FINAL DRAINAGE REPORT FOR BRANDING IRON AT STERLING RANCH FILING NO. 2

Engineering Review

**EPC Planning & Community
Development Department**

Project #09-012
EPC Project # **SF-19-018**

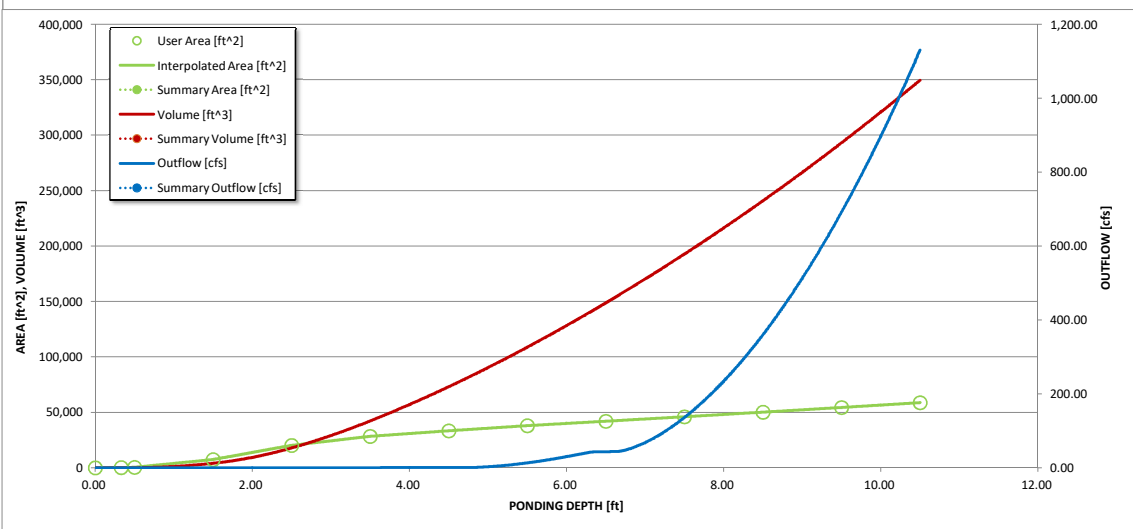
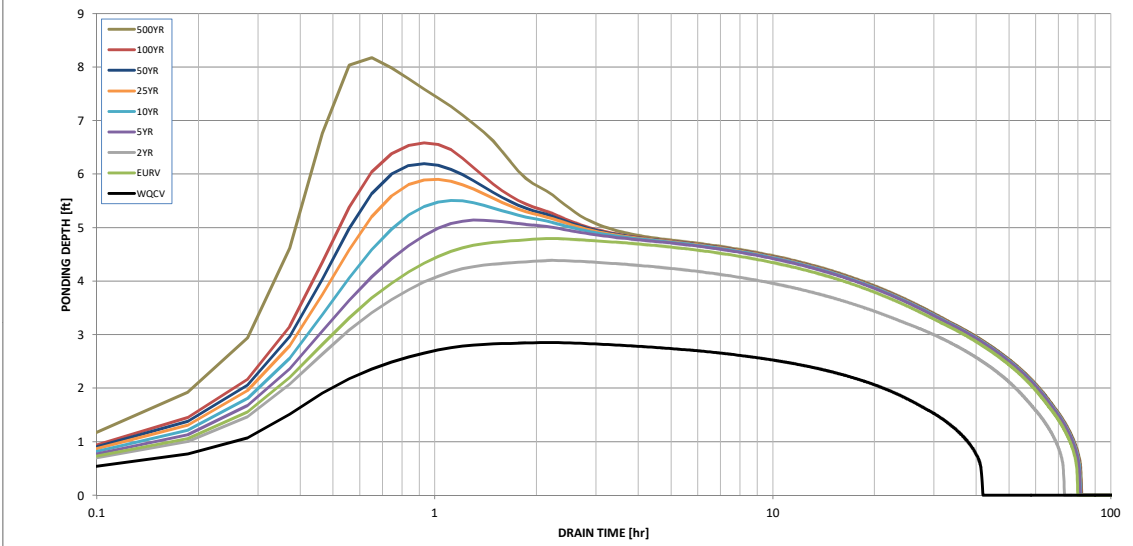
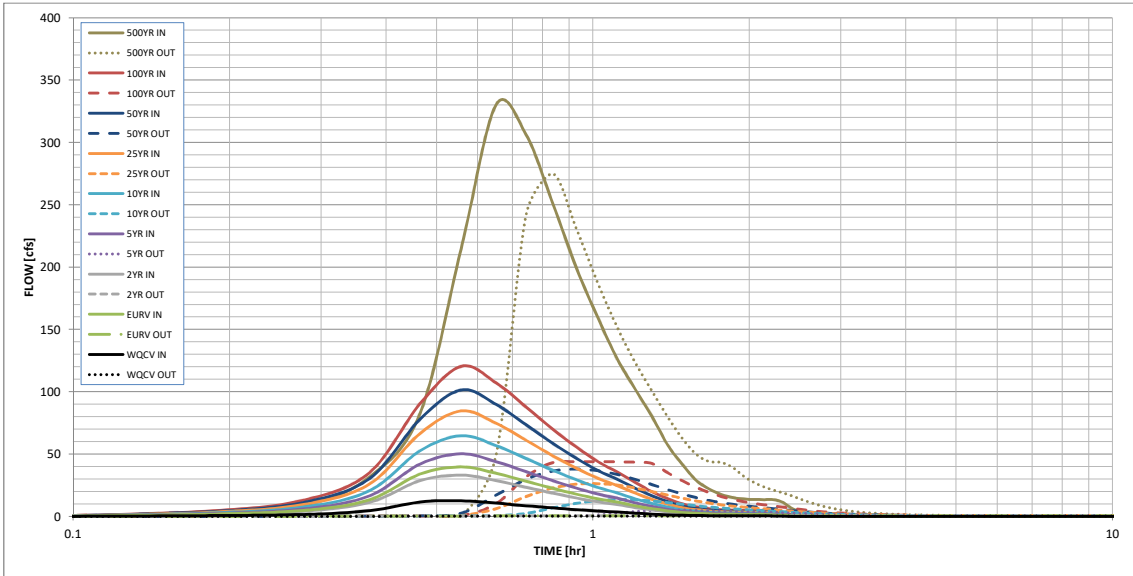
Can this be adjusted?

Hydraflow Storm Sewers Extension for Autodesk® AutoCAD® Civil 3D® Plan

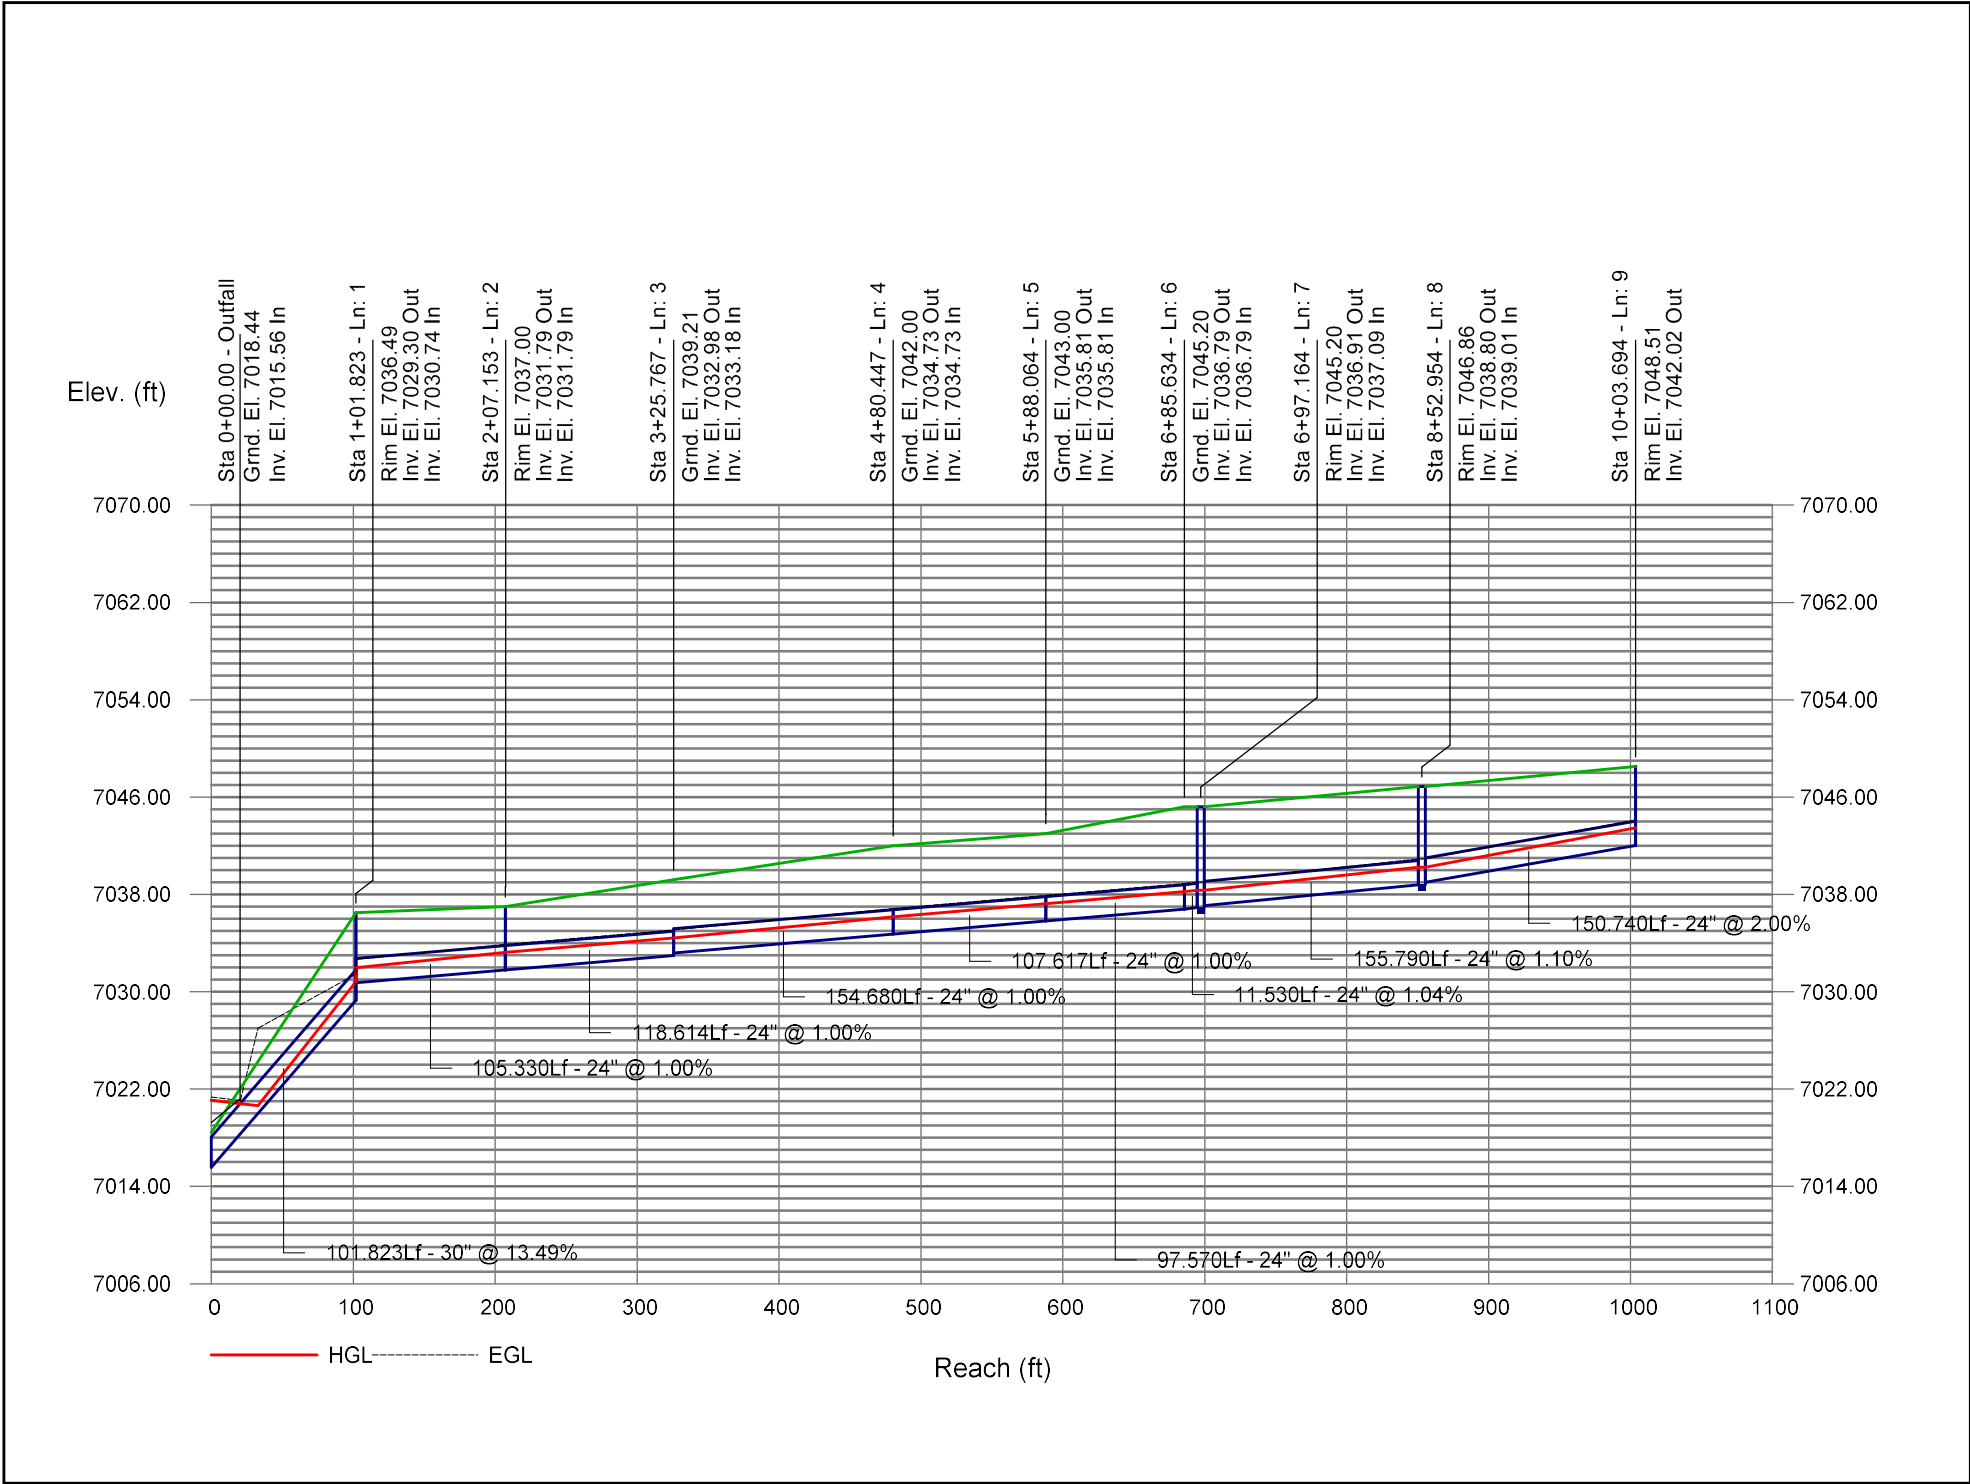
label 5 or 100-year storm; provide both

PROPOSED DRAINAGE MAP

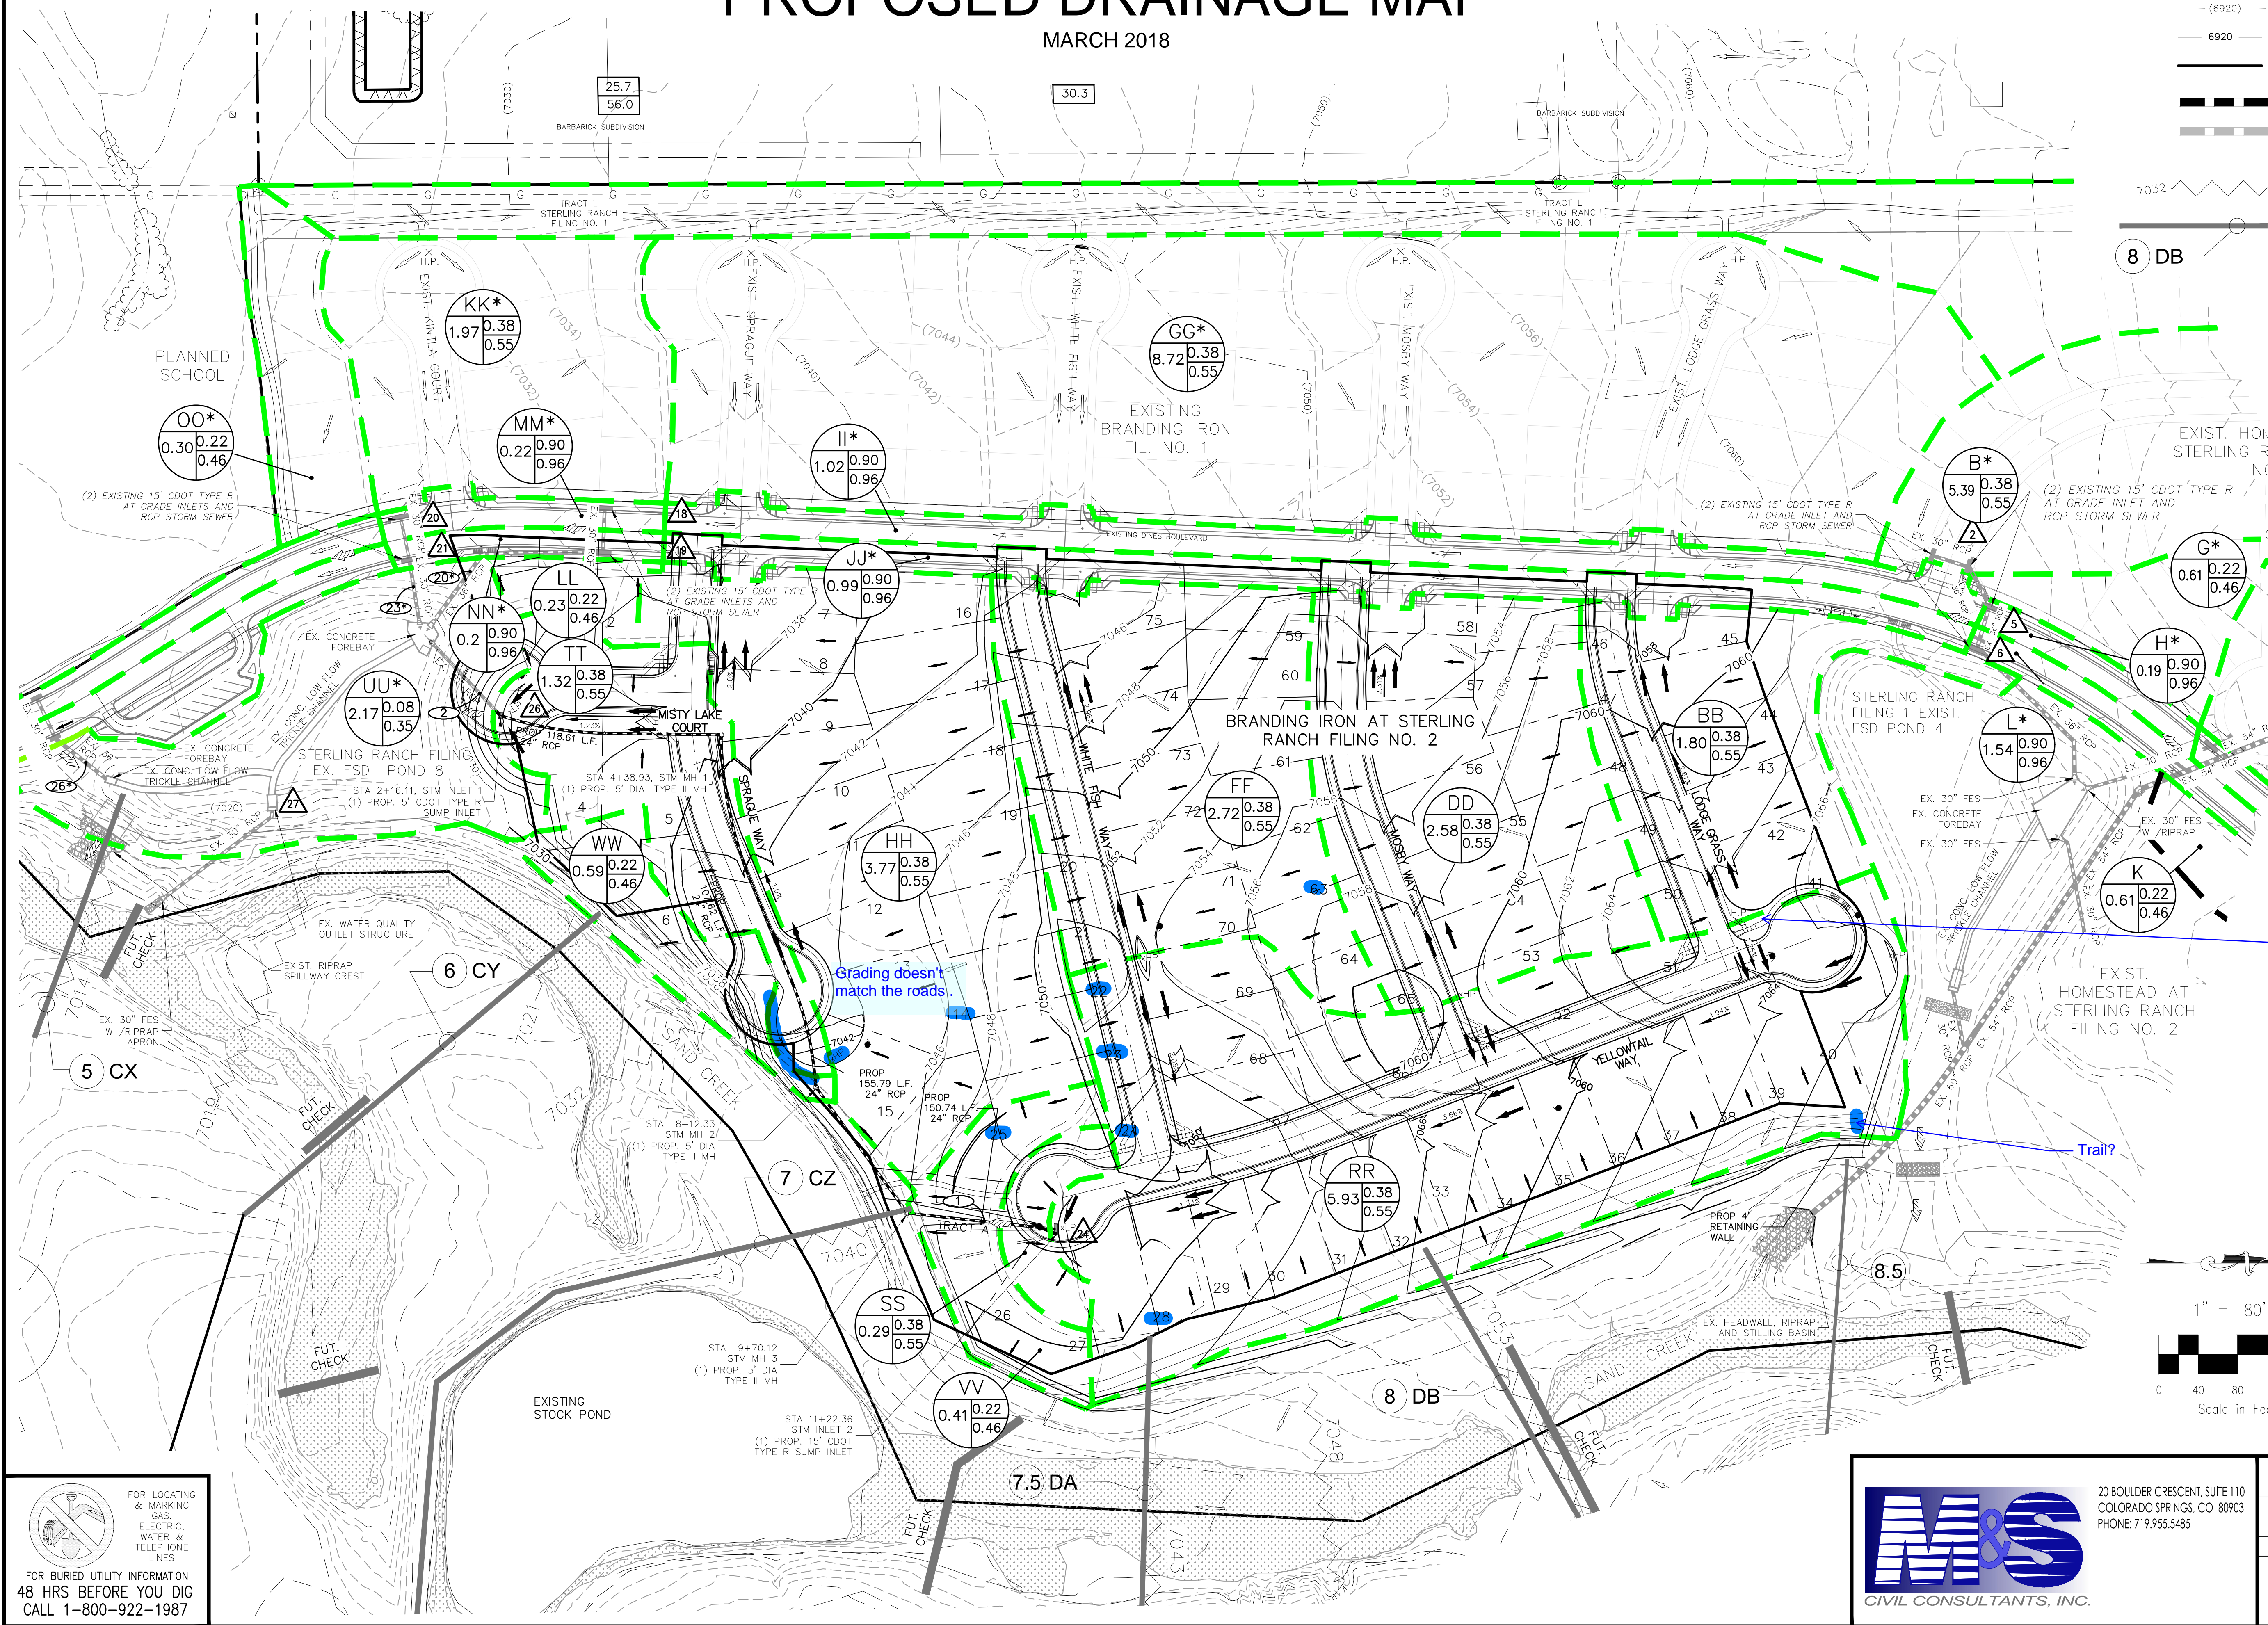
Provide Existing Conditions Plan.
